TENNESSEE VALLEY AUTHORITY
BROWNS FERRY NUCLEAR PLANT (BFN)
UNITS 1, 2 AND 3

PROPOSED TECHNICAL SPECIFICATION (TS) CHANGE TS-356
DESCRIPTION AND EVALUATION OF THE PROPOSED CHANGE

PROPOSED TECHNICAL SPECIFICATION (TS) CHANGE TS-356
MARKED PAGES

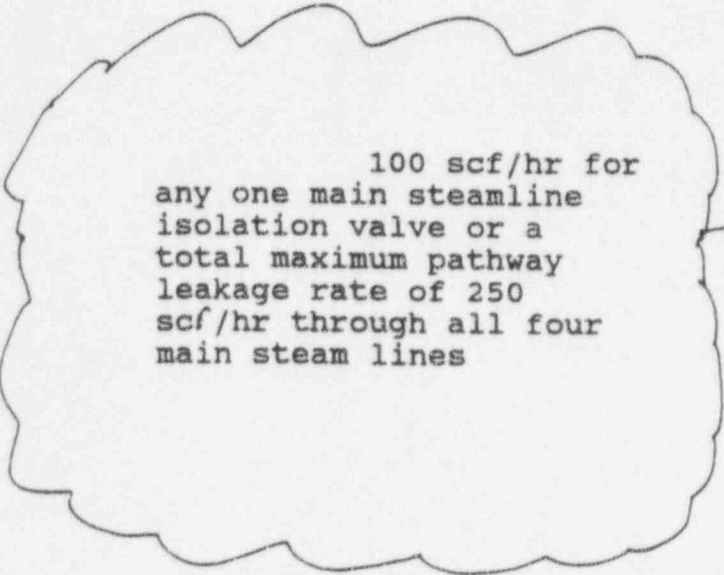
, except the main steam
isolation valves,

The total leakage from all penetrations and isolation valves shall not exceed 60 percent of L_a per 24 hours. Leakage from containment isolation valves that terminate below suppression pool water level may be excluded from the total leakage provided a sufficient fluid inventory is available to ensure the sealing function for at least 30 days at a pressure of 54.6 psig. Leakage from containment isolation valves that are in closed-loop seismic class I lines that will be water sealed during a DBA will be measured but will be excluded when computing the total leakage.

"The total leakage from all penetrations and isolation valves, except the main steam isolation valves, shall not exceed 60 percent of L_a per 24 hours."

4.7.A. Primary Containment

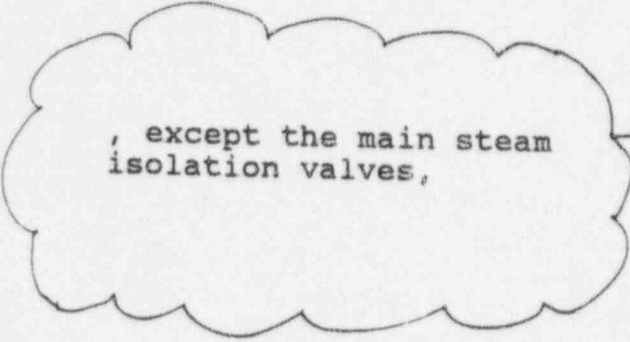
, except the main steam
isolation valves,

"The total leakage from all penetrations and isolation valves, except the main steam isolation valves, shall not exceed 60 percent of L_a per 24 hours."

SURVEILLANCE REQUIREMENTS

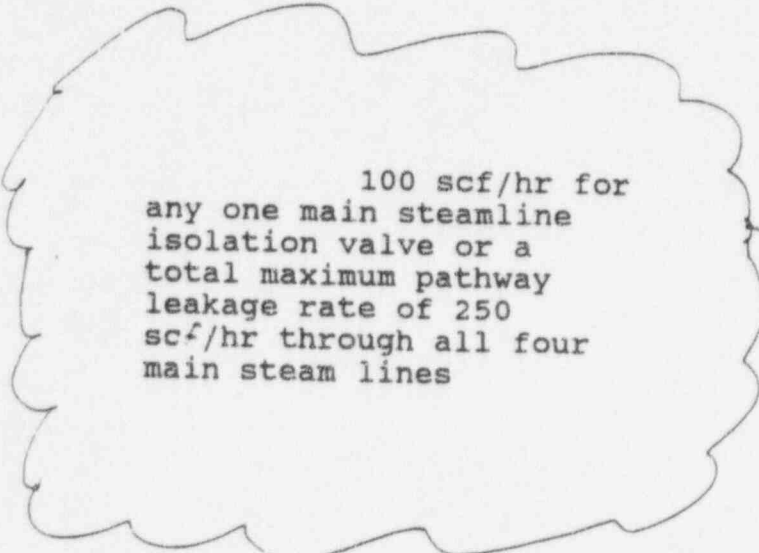
1. The main steamline isolation valves shall be tested at a pressure of 25 psig for leakage during each refueling outage. If the leakage rate of ~~11.5 scf/hr for any one main steamline isolation valve~~ is exceeded, repairs and retest shall be performed to correct the condition.

"The main steamline isolation valves shall be tested at a pressure of 25 psig for leakage during each refueling outage. If the leakage rate of 100 scf/hr for any one main steamline isolation valve or a total maximum pathway leakage rate of 250 scf/hr through all four main steam lines is exceeded, repairs and retest shall be performed to correct the condition."
